# Proposed Design Sustainability

# Design Revisions Item #1 - Internal Pick Up & Drop Off

Revised 'Hyphen' Facade

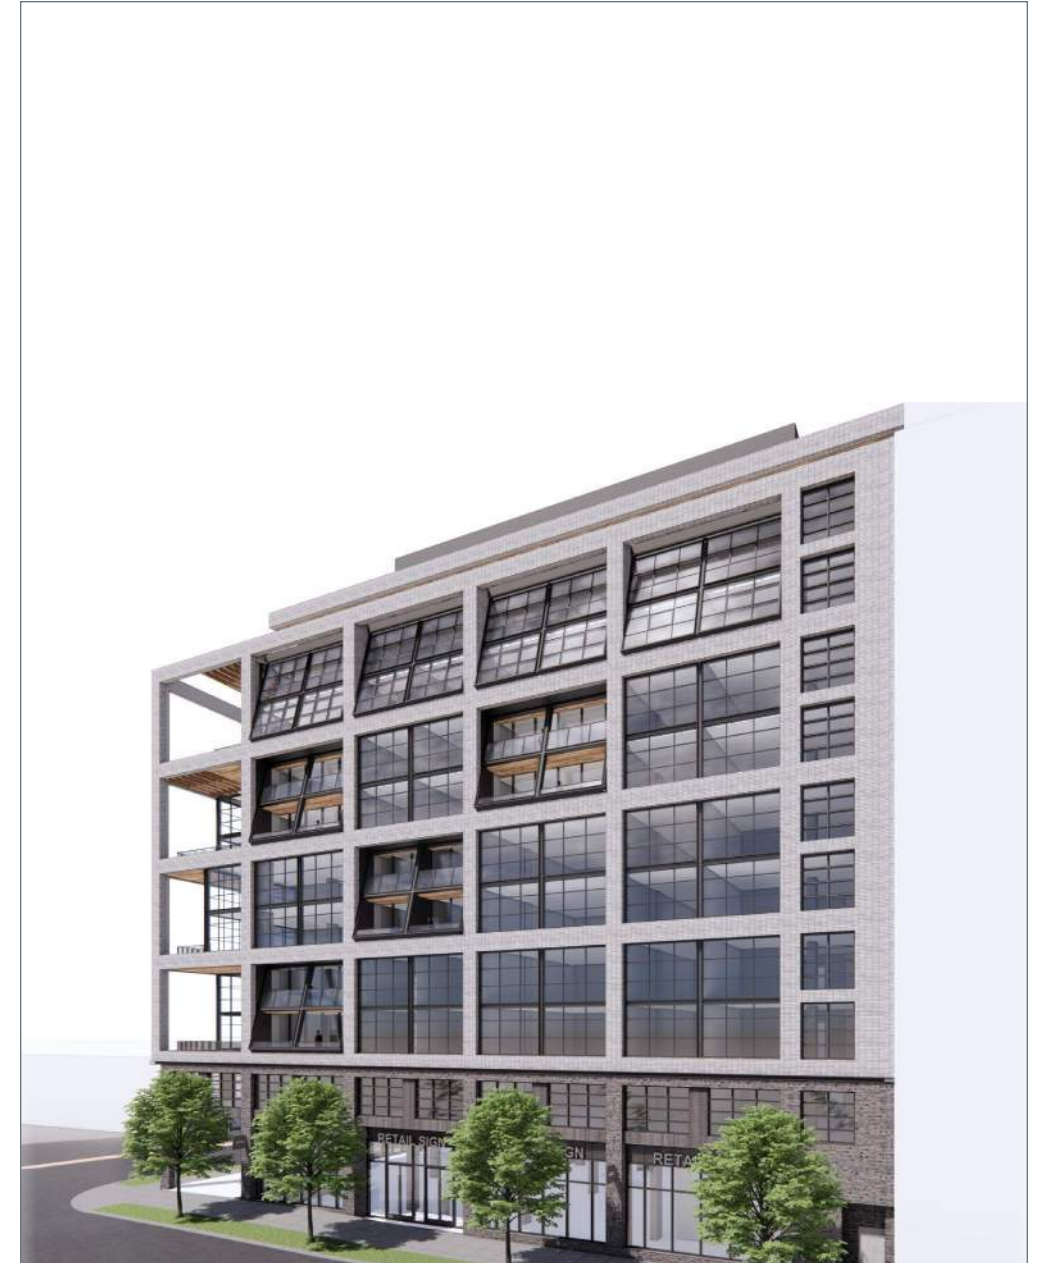
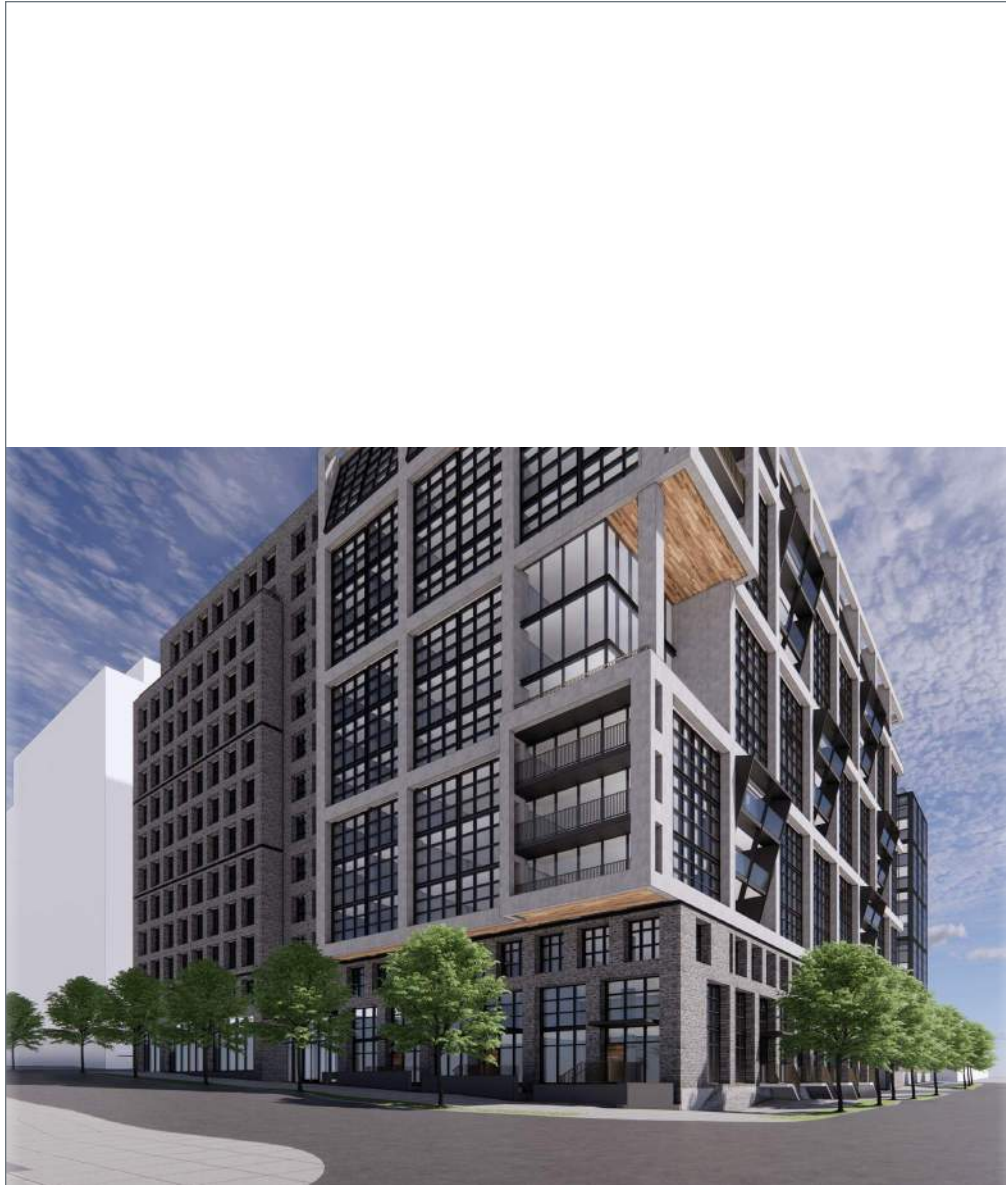
- Added balconies.
- Updated brick detailing to reflect the mid-century detailing prevalent in Southwest.
- Introduced additional reveals in the massing.
- Enlarged window openings / increased glass.

- Removed the 'hyphen' facade to consolidate the design vocabulary.
- Added more rotated windows and balconies.
- Updated the rotation of the rotated balconies to be consistent and not rotate out at the top of the opening (now inwardly-rotate).
- Converted precast concrete grid to brick.

Revised Facade

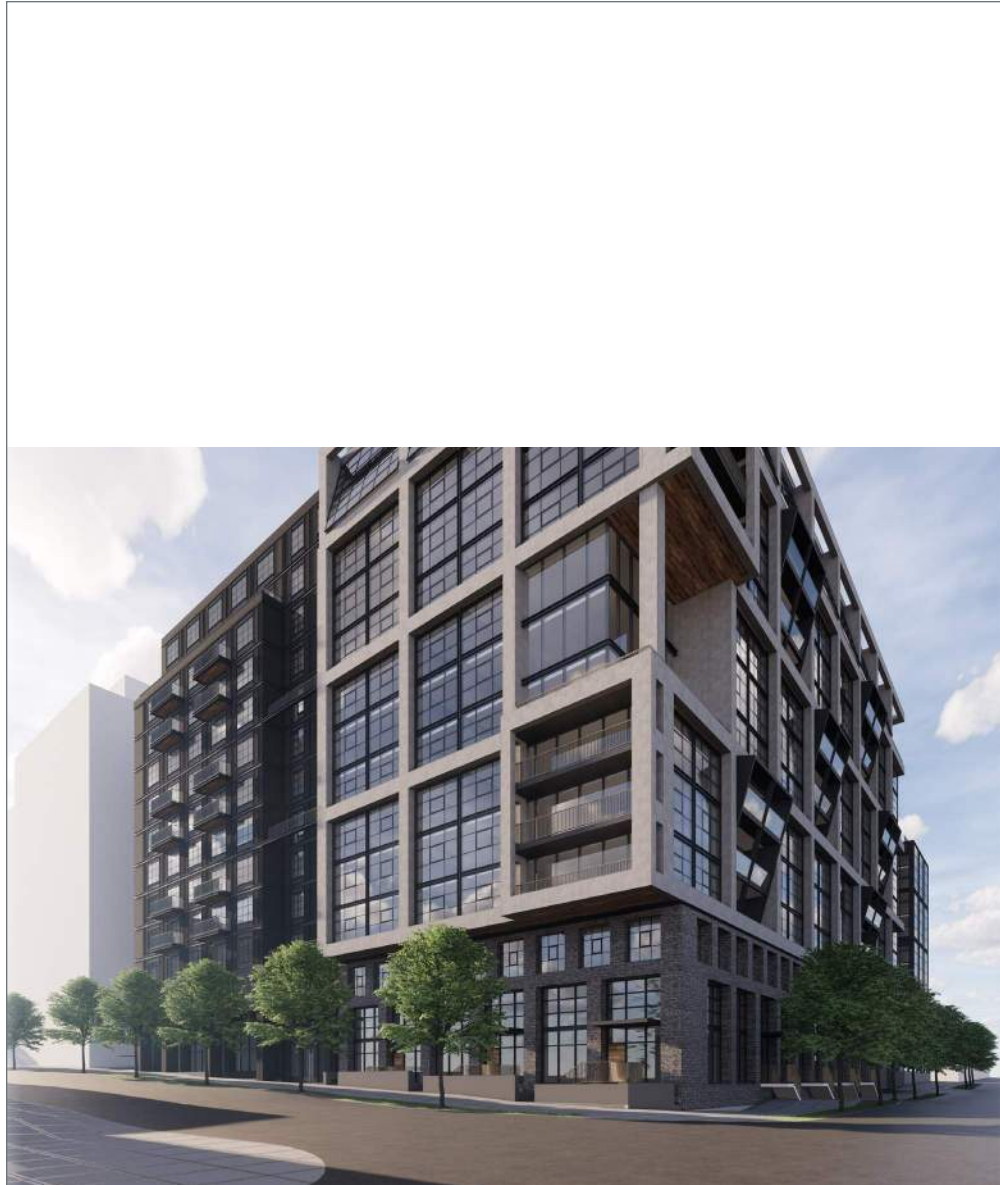
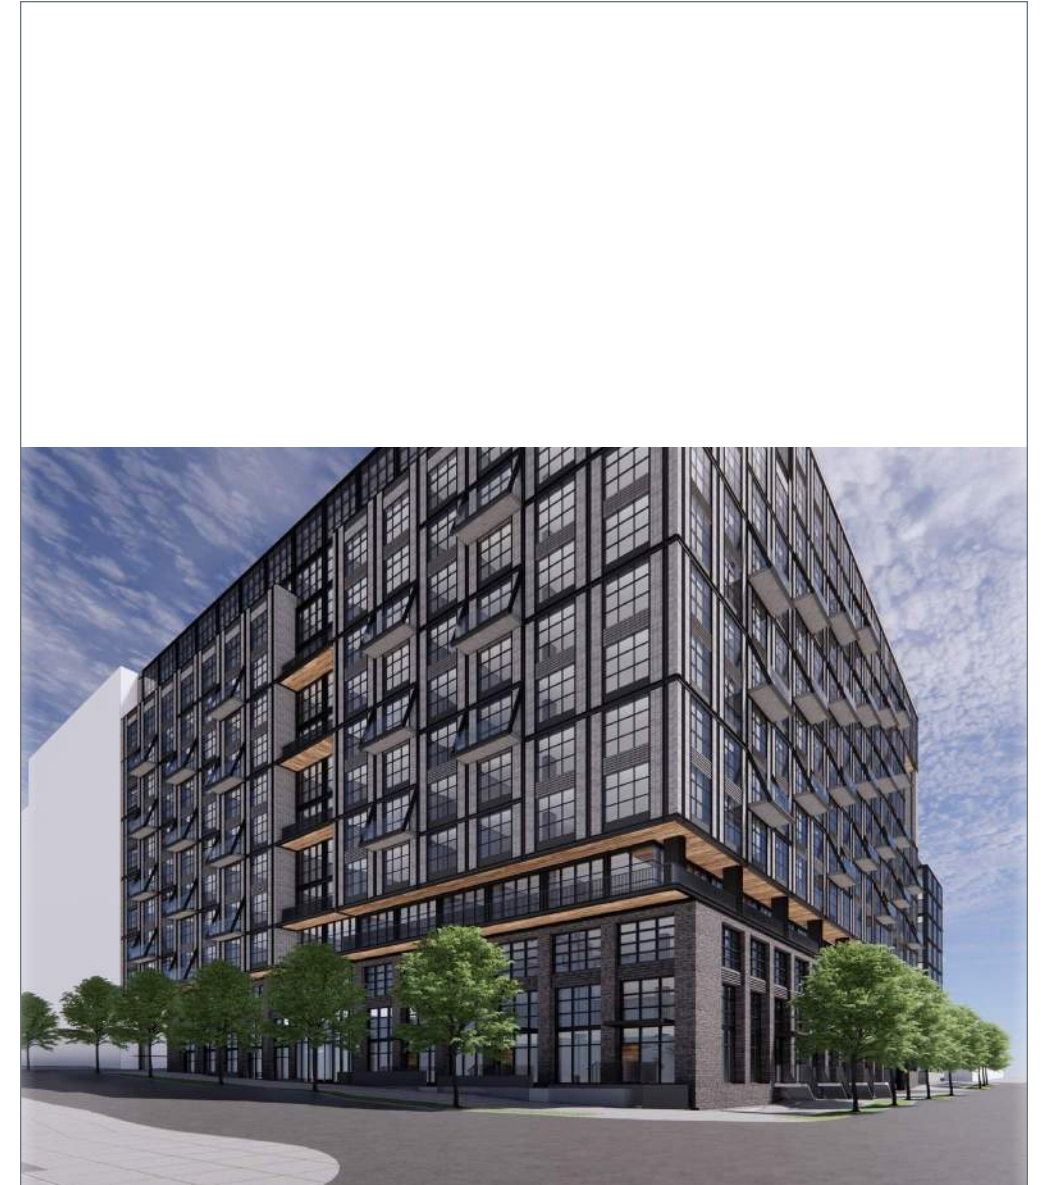
- Added balconies.
- Updated brick detailing to reflect the mid-century detailing prevalent in Southwest.
- Introduced additional reveals in the massing.
- Enlarged window openings / increased glass.

- Removed the precast grid facade to consolidate the design vocabulary.
- Added more balconies.
- Added reveals between podium and tower.
- Introduced the same facade type from the pavilion to new upper story setbacks to consolidate design vocabulary.

Revised Pavilion and West Facade

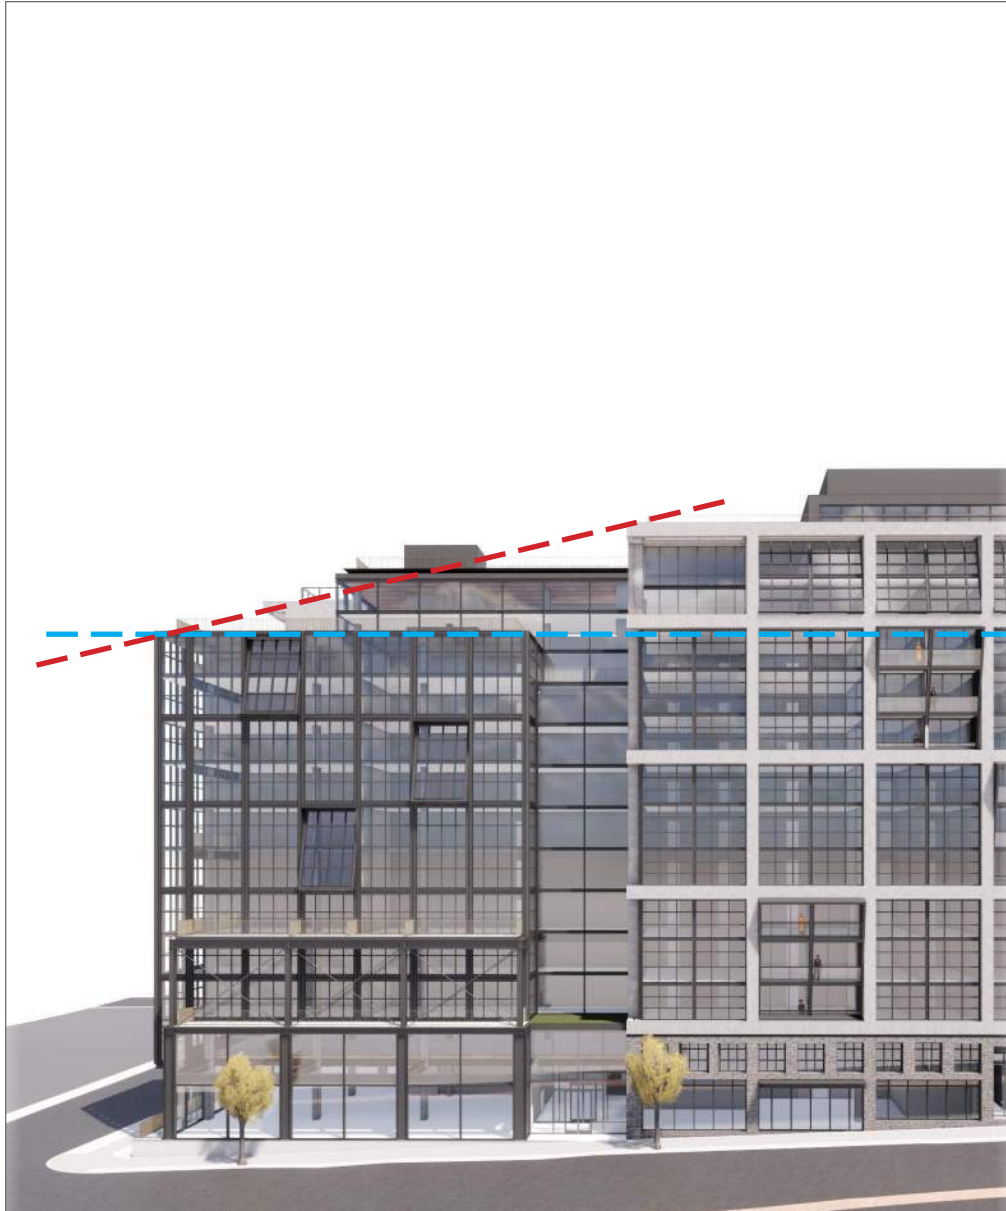
- Simplified the facade to exclude rotated windows and removed exoskeleton.
- Tiered the massing to allow for a more varied roofline.

- Removed the tiering of the pavilion to allow for open air porosity to courtyard.
- New brick facade type consolidated to the northwest building
- Added balconies to west facade.
- Added 3-story inset for southern views.
- New inset corresponds with new outdoor amenity at pavilion roof.

Revised Pavilion

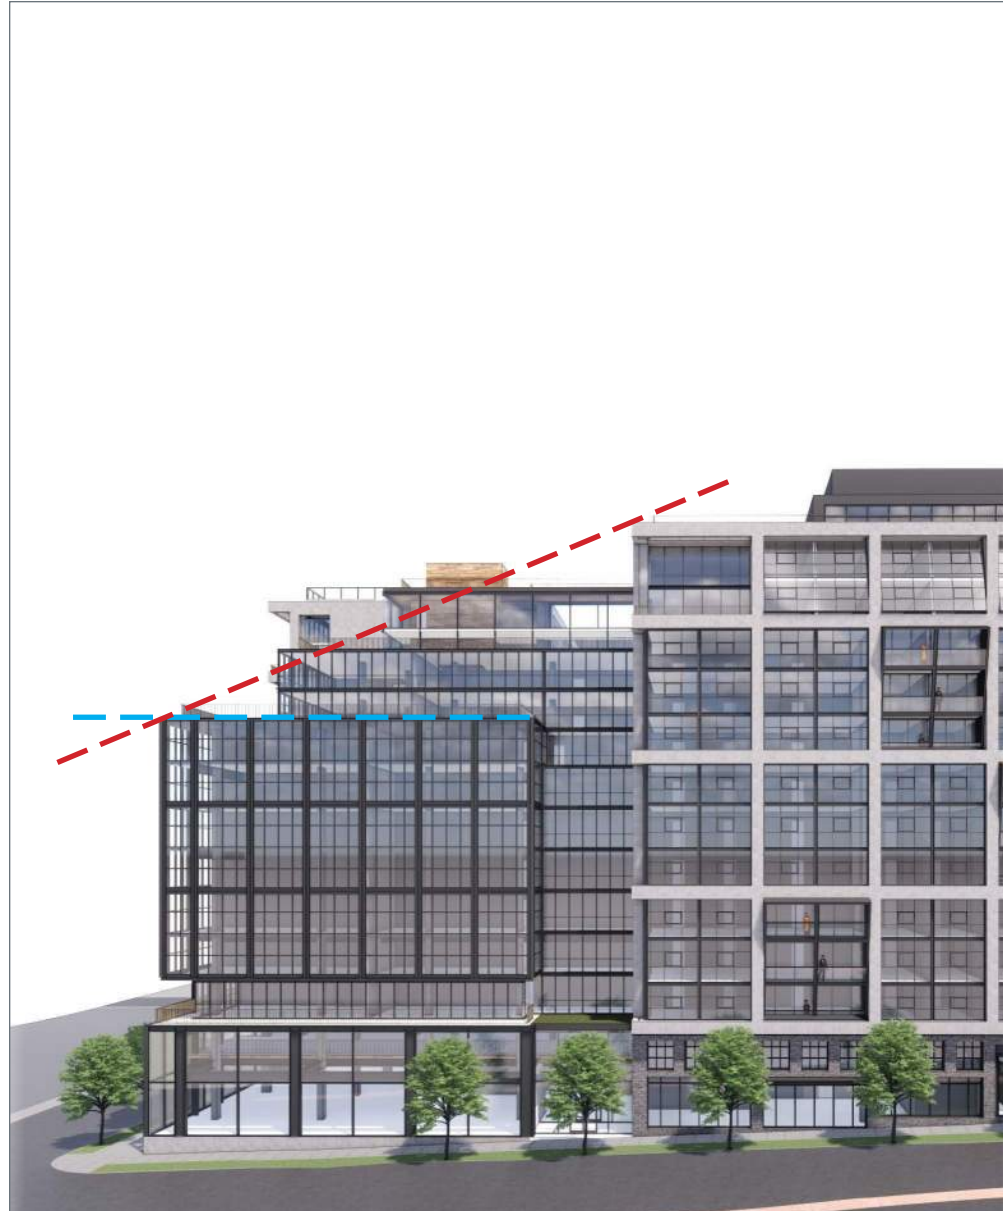
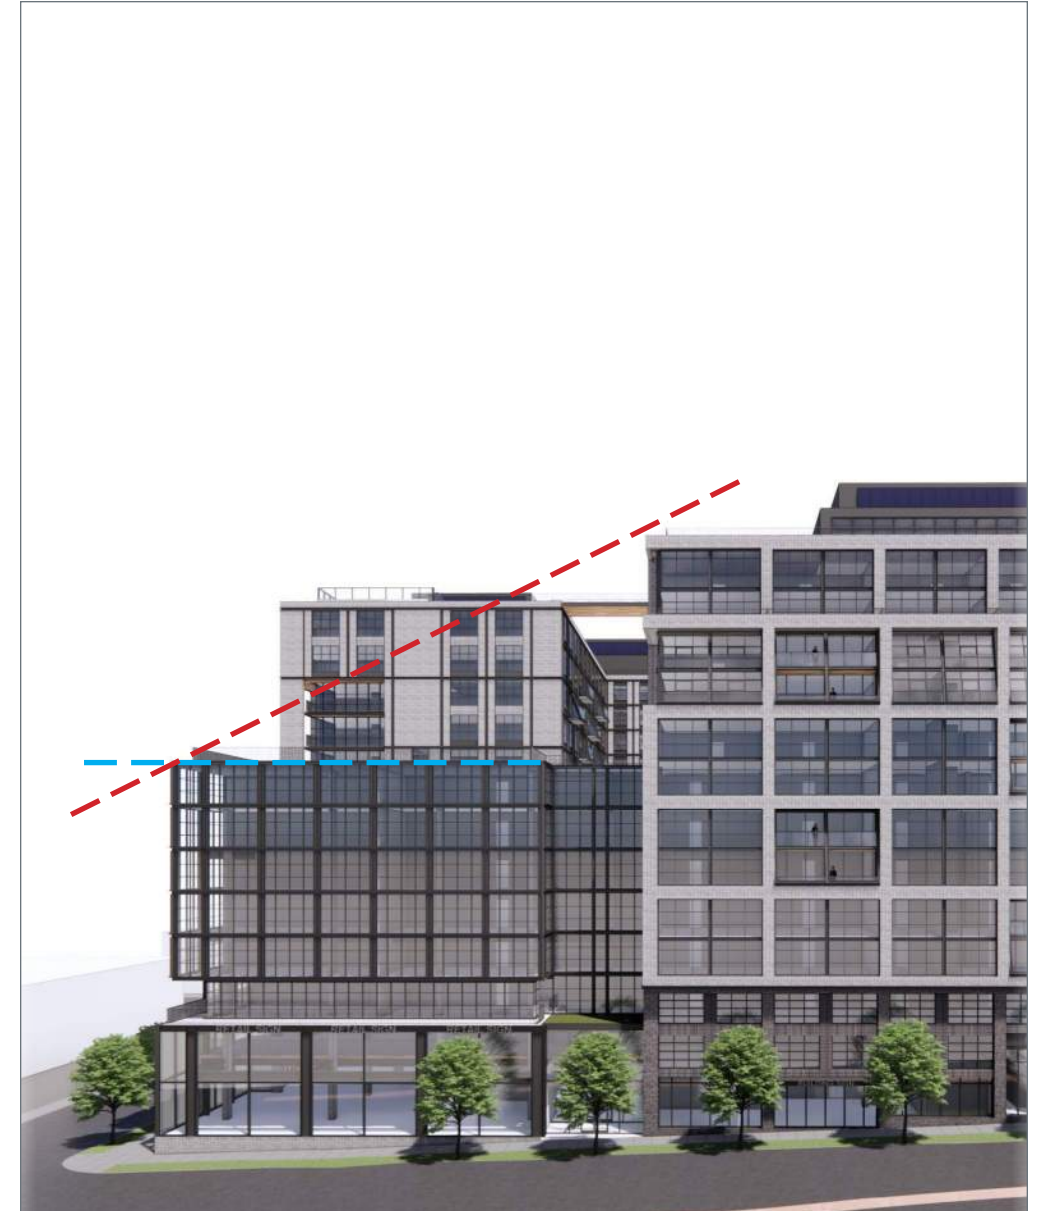
- Simplified the facade to exclude rotated windows and removed exoskeleton.
- Tiered the massing to allow for a more varied roofline.

- Removed the tiering of the pavilion to allow for open air porosity to courtyard.
- Added 3-story inset for southern views.
- New inset corresponds with new outdoor amenity at pavilion roof.
